**ADDENDUM 001
REQUEST FOR BIDS
(STRUCTURED TELECOMMUNICATIONS CABLING SYSTEM)
RFB # (D8PP-10061)**

MISSOURI DEPARTMENT OF TRANSPORTATION DISTRICT 8 OFFICE

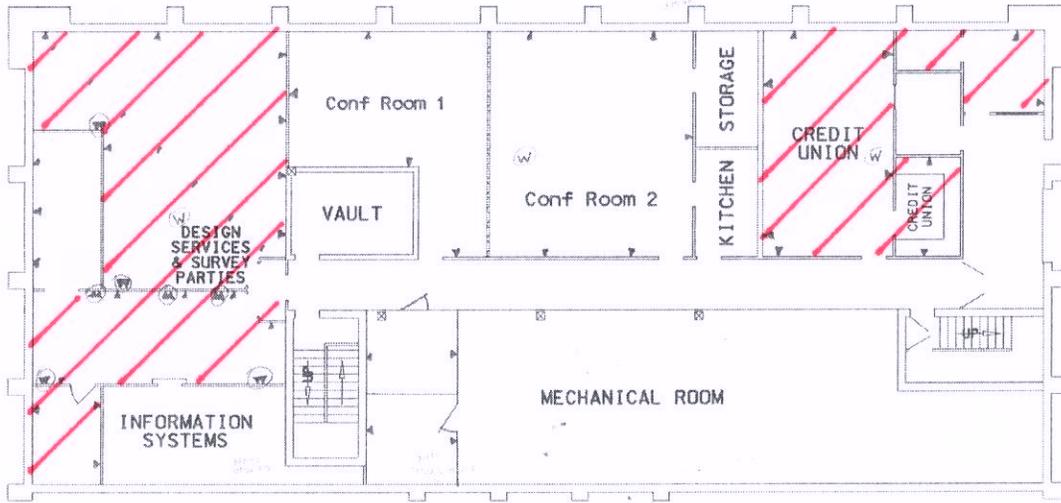
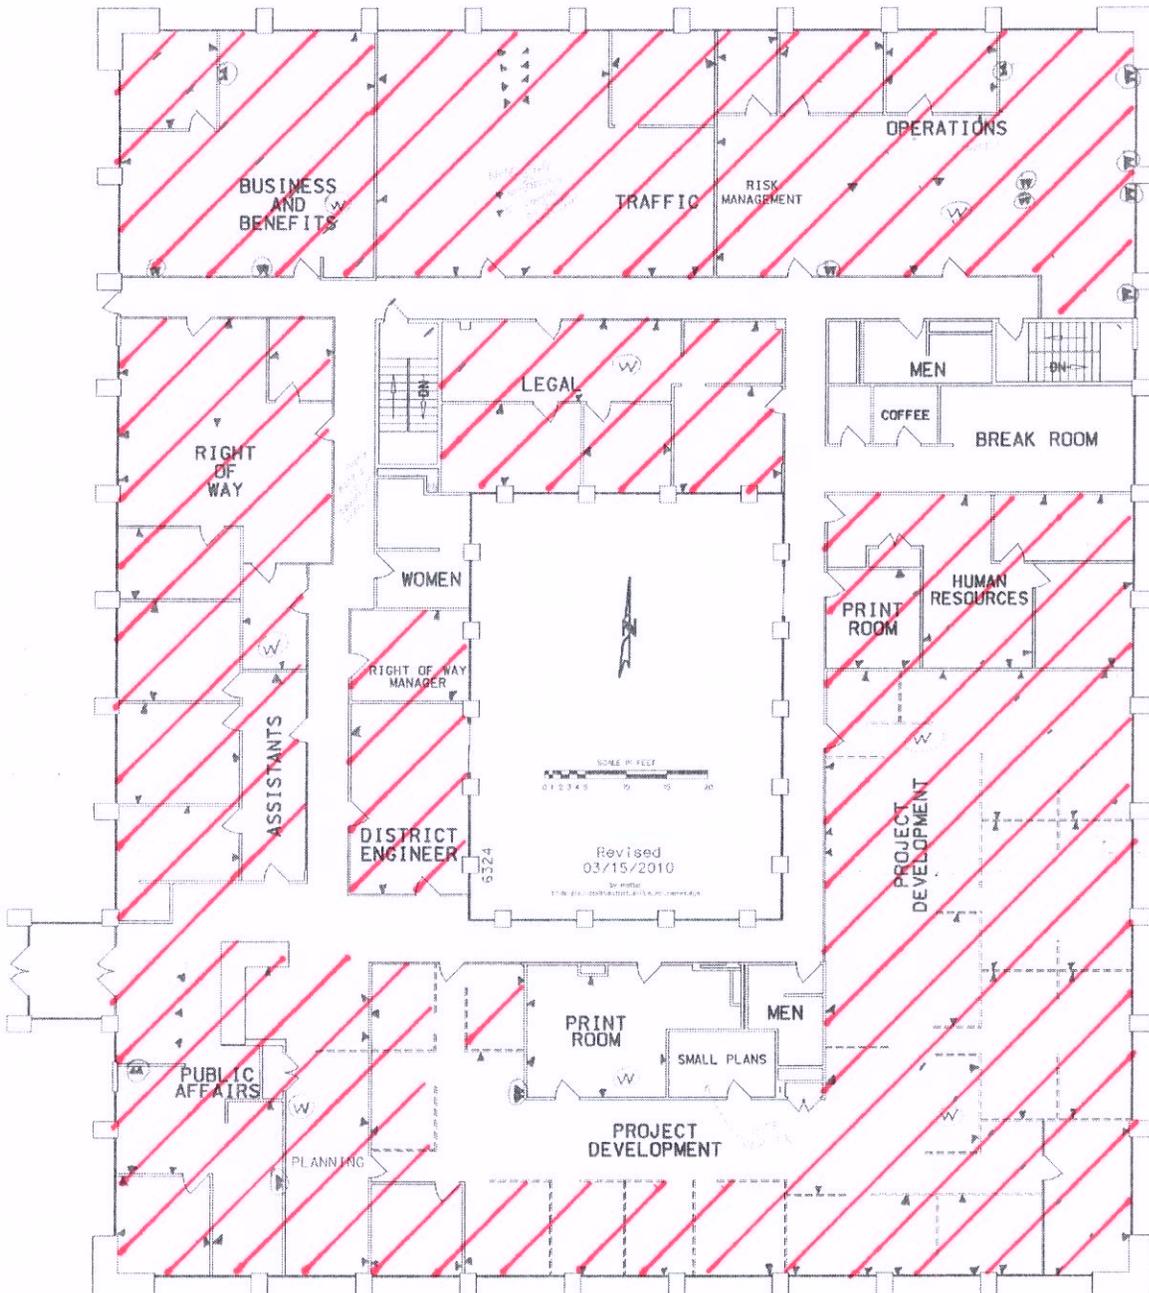
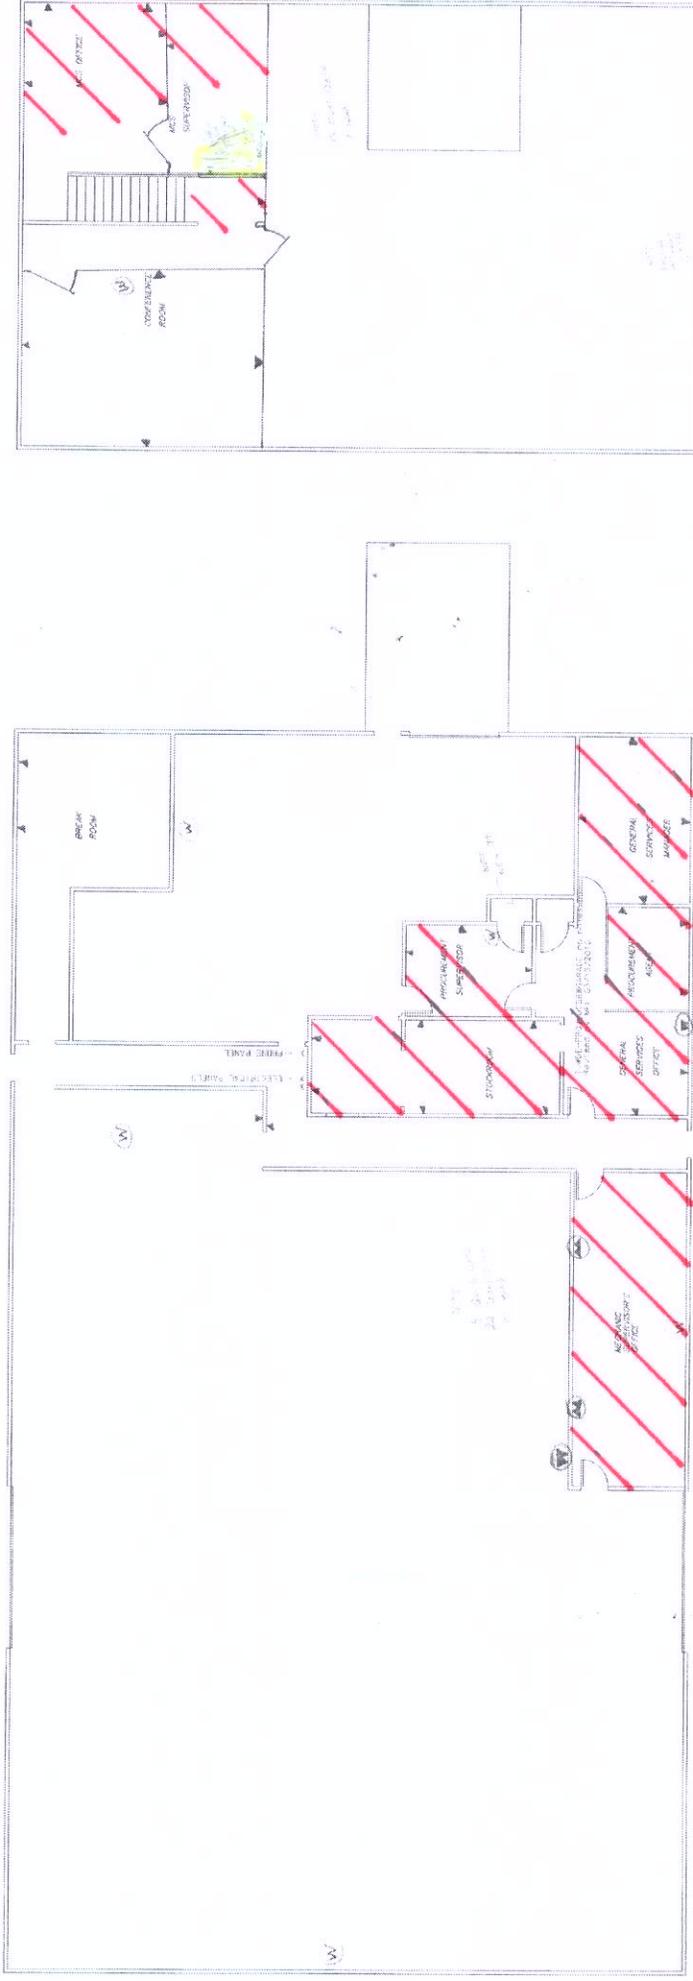
Work to be performed after hours
or on weekends.

Conference rooms may be reserved
for 7:30 AM – 4:00 PM work.

Work to be performed after hours
or on weekends.

Conference rooms may be reserved
for 7:30 AM – 4:00 PM work.

The contractor shall be required to coordinate work schedules with MoDOT's designated representative. See the PDF document titled "Work Hour Restrictions Map", for areas known to require after hours work. Per the attached map, all work done will be required to be done after 4 pm C.S.T. or on weekends with prior approval from MoDOT's representative. Any work performed in non-restricted areas during MoDOT's standard work hours (7:30 a.m. to 4:00 p.m. C.S.T.) may be performed with prior coordination with MoDOT's representative.
